Request for Class II Permissive Change(C2PC)

FCC ID: VG8EM925AYYGEW2

This is a C2PC application for which the previous grant was issued on 2022-06-13.

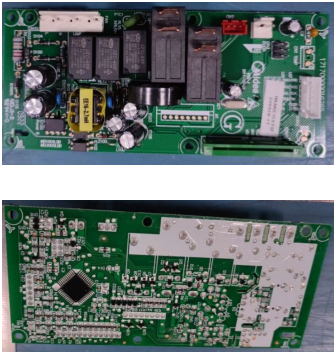
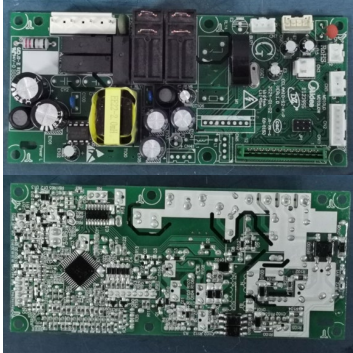
No.:	Original	New	Difference(s)
1			Keypad: Updated front keypad to accommodate child lock function (Child resistant oven door function).
2			Mother board: Modified the peripheral circuit (non-RF circuit) and some individual components and PCB layout. The magnetron and other circuit are exactly same as before.
3	Not Applicable		The new one adds a solenoid valve locking mechanism, the original is not.
